# Chelan County Public Works Department

January 16, 2026  
**Addendum No. 4**  
Page 1 of 6

## RE: CRP 650, Totem Pole Road Phase I Road Improvement Project

Drawing No. **WD1**  
Sheet No. **31** / **50**

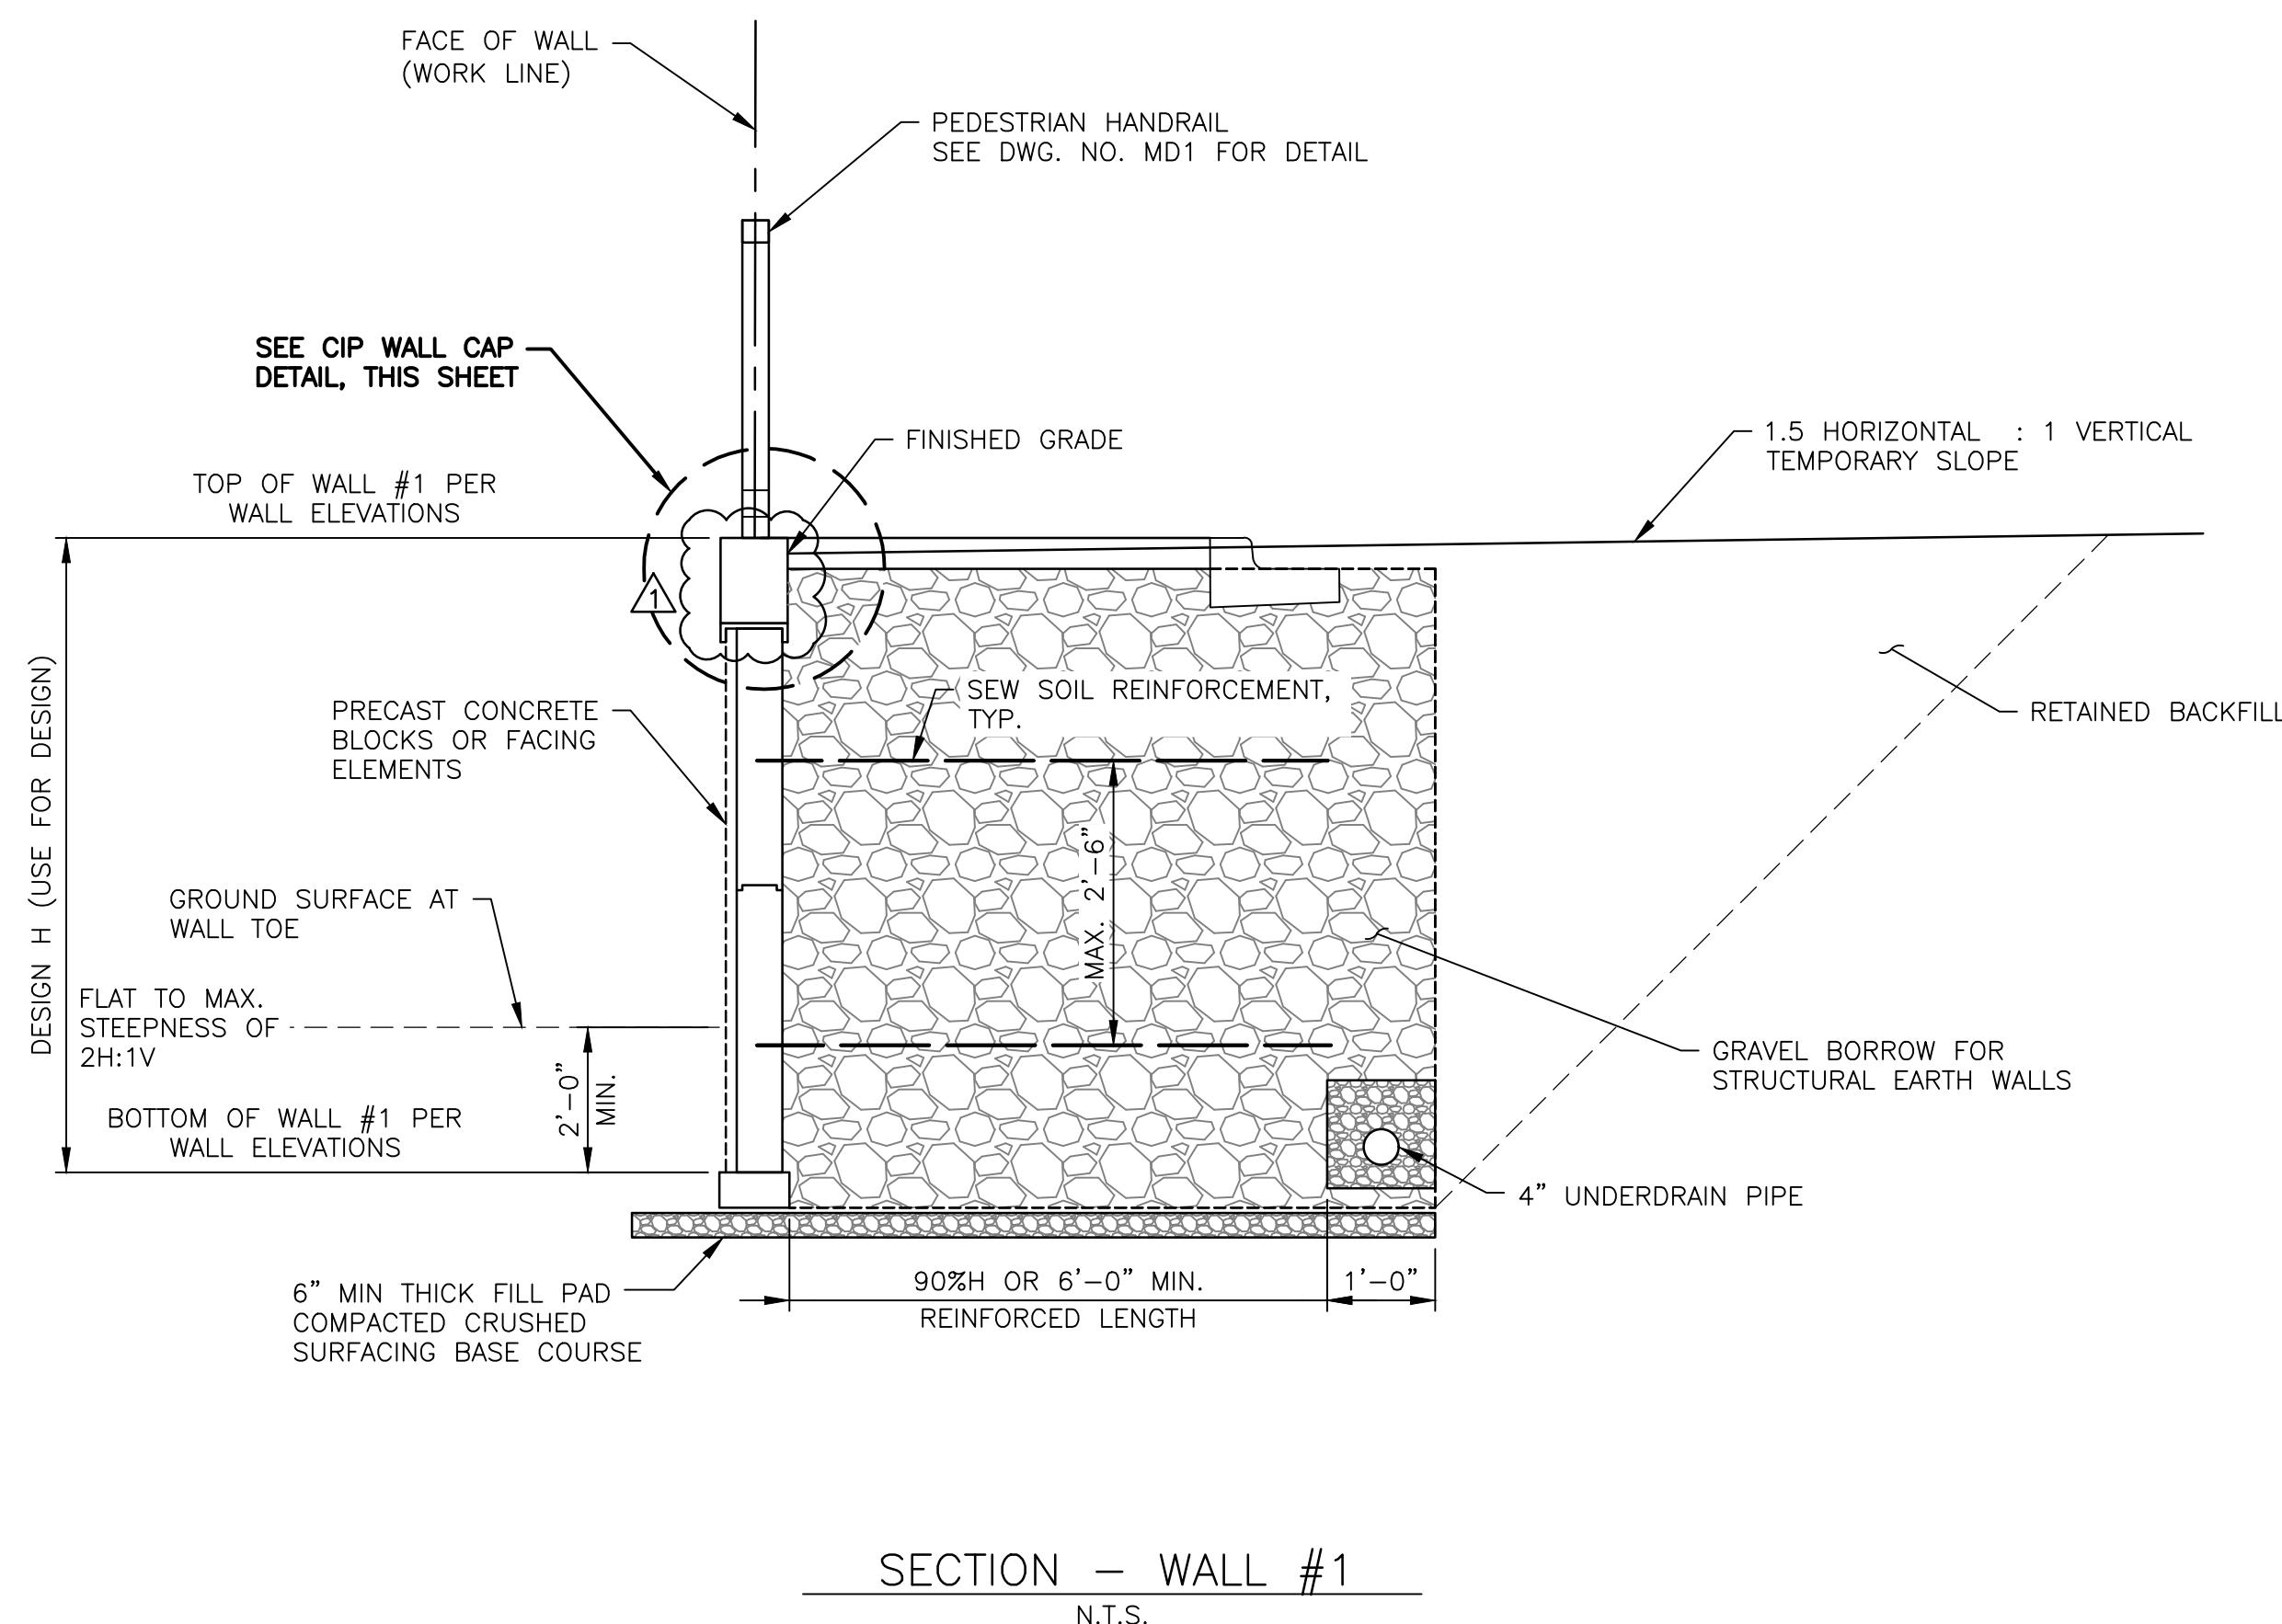
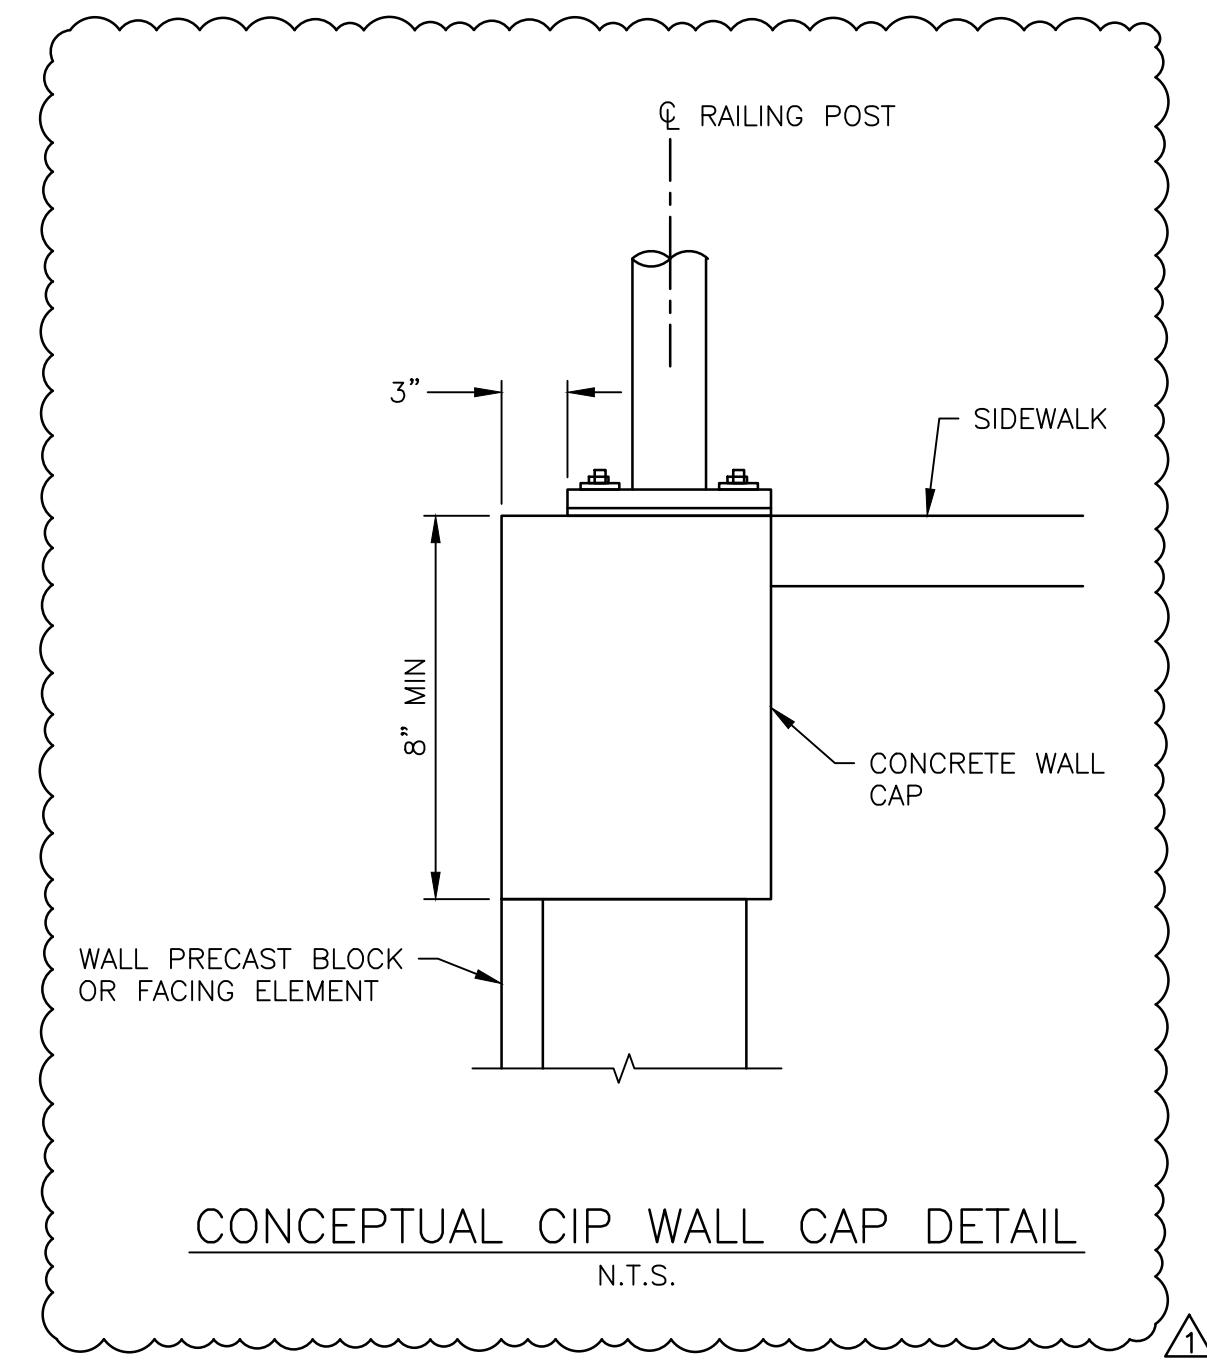
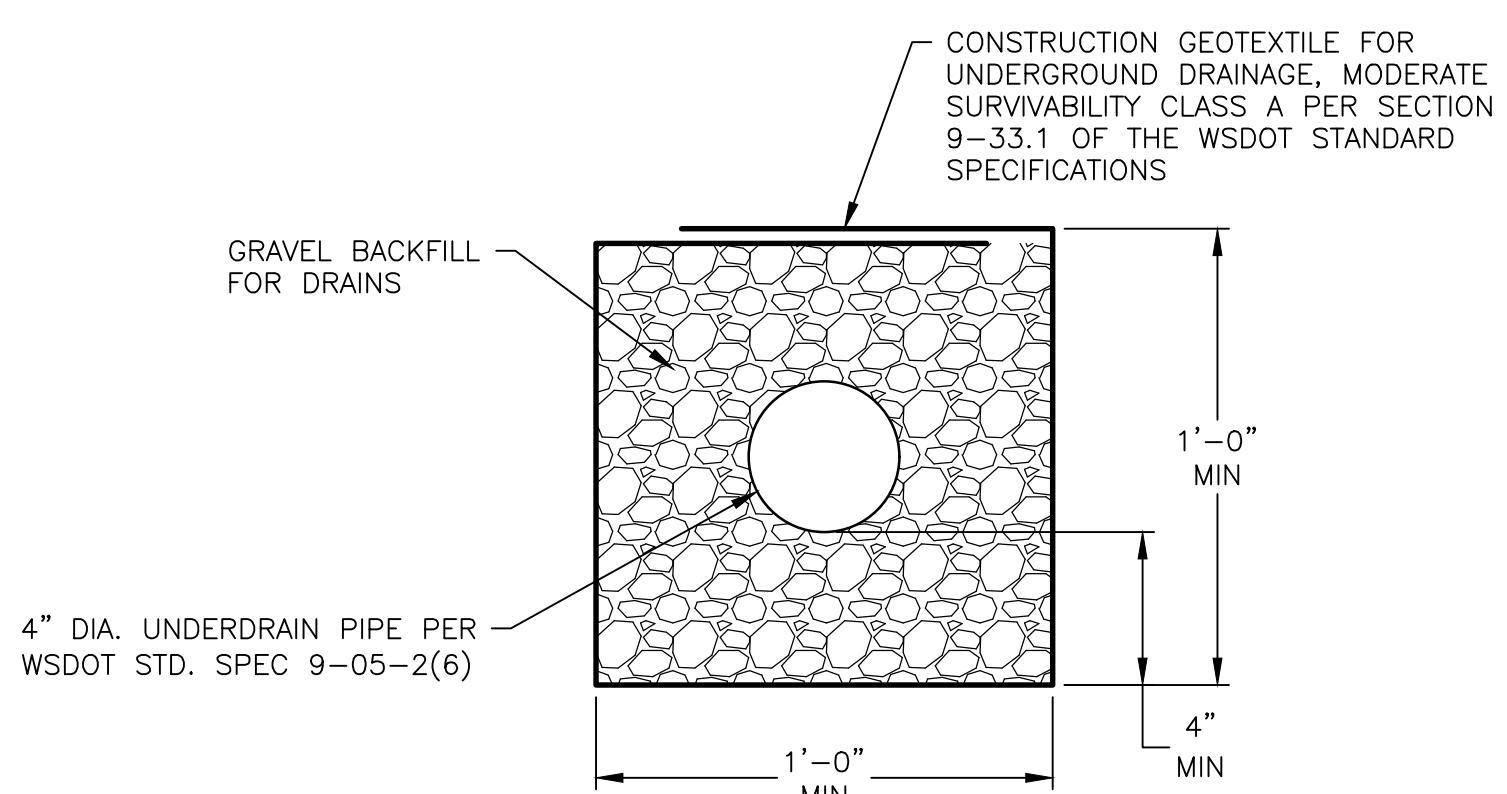
1. Remove the following plan sheets and replace in their entirety with attached Addendum No. 3 Plan Sheets:

WP1 (Supersedes note change from Addendum 1), WD1, MD1

1. Question: Multiple Contractors and Suppliers asked for clarification regarding retaining wall type, retaining wall cap, and mounting the pedestrian railing to Wall #1. Additionally, Contractors requested an alignment for Wall #1.

Answer: See included changes to Special Provisions and attached, revised, Plan Sheets for clarifications.
